TOWN OF FAIRFAX STAFF REPORT

TO: Planning Commission
DATE: August 25, 2022
FROM: Linda Neal, Principal Planner
LOCATION: 125 Live Oak Avenue; APN # 001-236-03
ZONING: Residential RD 5.5-7 Zone
PROJECT: Construction of a single-family residence, Accessory Dwelling Unit and parking
ACTION: Hill Area Residential Development Permit, Design Review Permit, Excavation Permit, Tree Removal Permit and Encroachment Permit, Parking Variance and Minimum and Combined Side-yard Setback Variances; Application # 22-17
APPLICANT: Bacilias Macias, Architect
OWNER: Paul and Maria Cadieux
CEQA STATUS: Categorically exempt, §15303(a)

125 LIVE OAK AVENUE

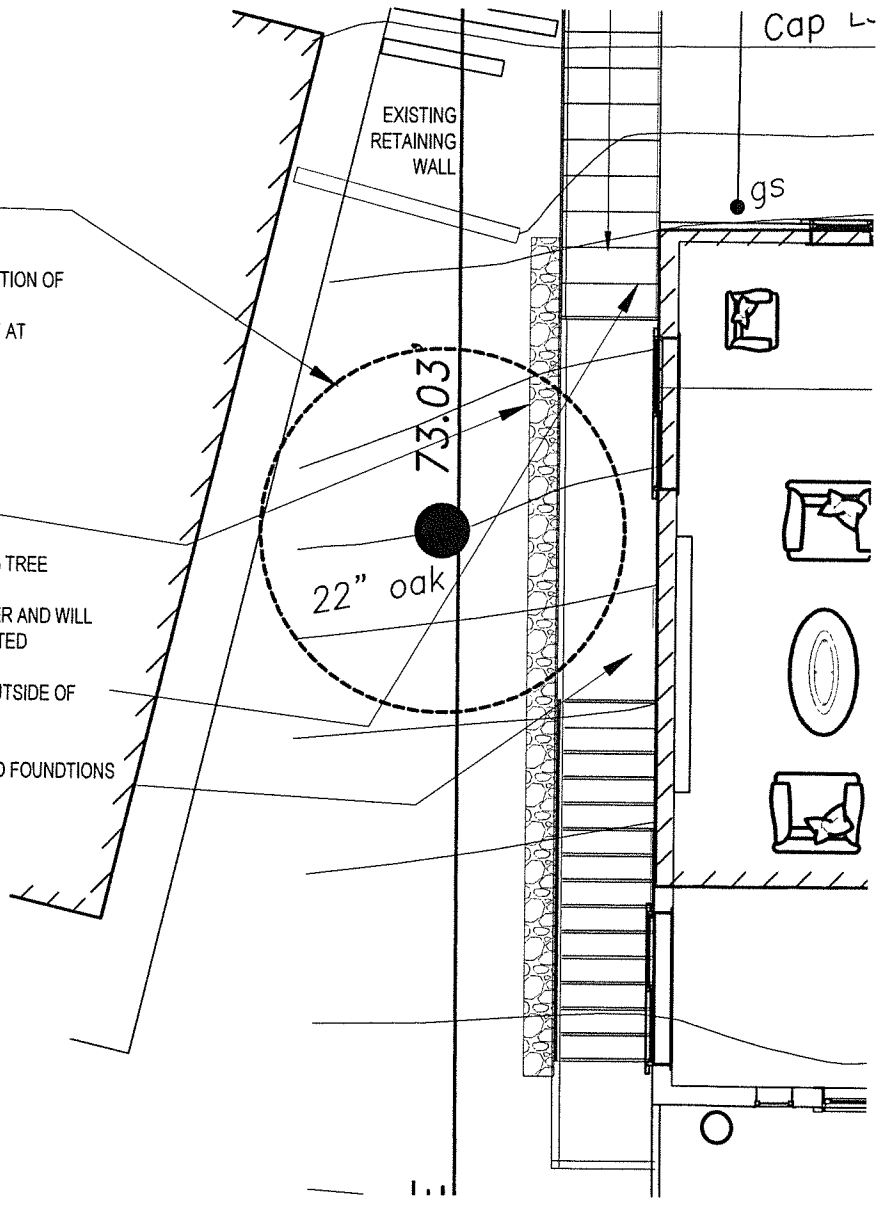
PROTECTION FENCE CAN BE MOVED FOR CONSTRUCTION OF
ELEMENTS ABOVE GRADE
SUCH AS LANDING AT STAIRS, FOR NEW STORM DRAIN AT
PERIMETER OF FOUNDATION AND SWALE

ARBORIST TO BE PRESENT DURING TRENCHING
AND INSTALLATION TO ASSURE
ROOTS OF TREE STAY IN TACT

PROPOSED SWALE IS 1" IN DEPTH AND
12" WIDE AND CAN BE LOCATED AT PROPOSED
LOCATION WITHOUT COMPROMISING THE WELL BEING TREE
